NUMBER
DEP16192

1. To provide answer to questions regarding the above solicitation.
2. To provide alternate bat gate drawings.
3. To provide a copy of the mandatory pre-bid meeting sign-in sheets.
4. To provide addendum acknowledgement.

DEP16192
Mallory (Gibson) Portals
Addendum #1

Item 29: The alternate bat gate detail shown below may be used, if desired, instead of the bat gate detail on sheet D4.

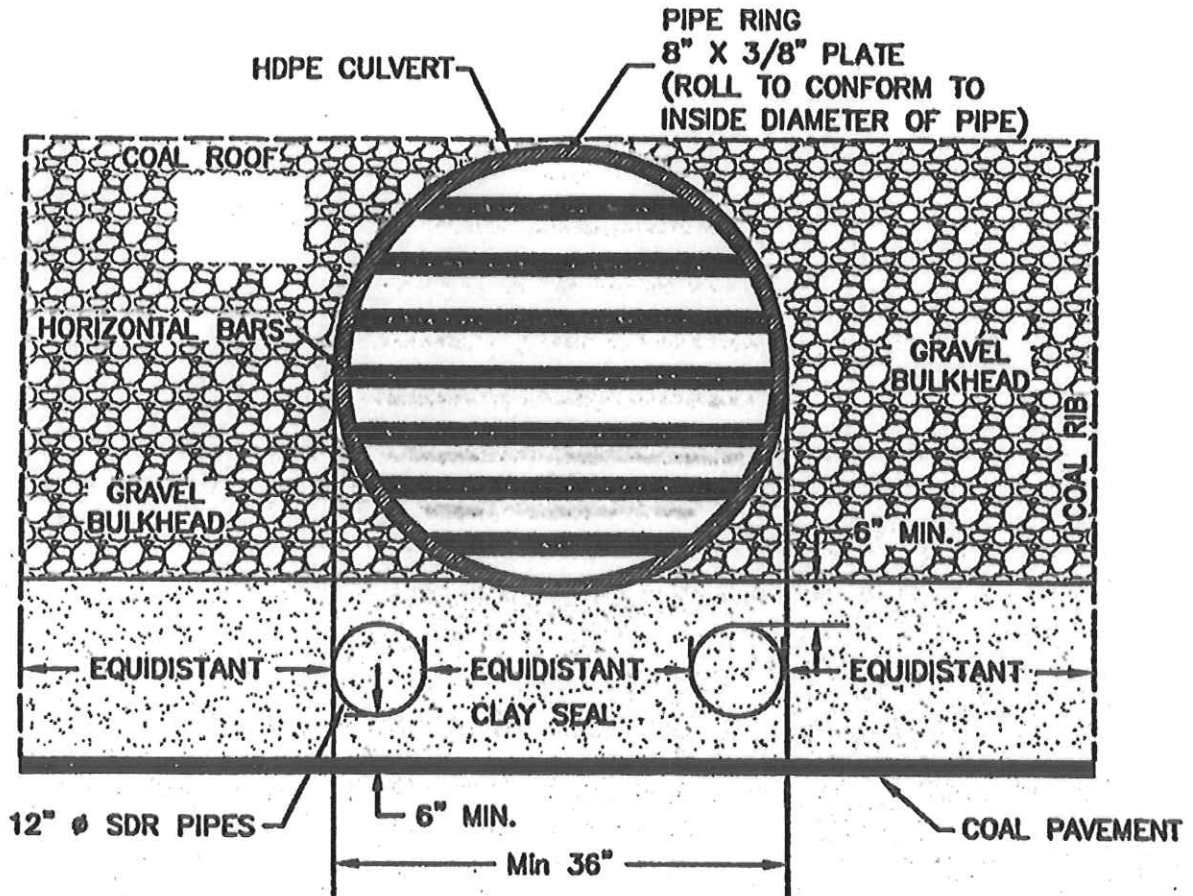
- Item 28: Q - On drawing number D4, may an alternate bat gate design be used? (This drawing is not the standard WVDEP bat gate detail.)
A - The bat gate illustrated on D4 may be used. Alternately, our "standard" bat gate may be used (sample drawings attached as items 29, 30 and 31). There is no difference on the bid sheet.

Note: For informational purposes only. Not to scale. (Shown with conveyance pipes.)
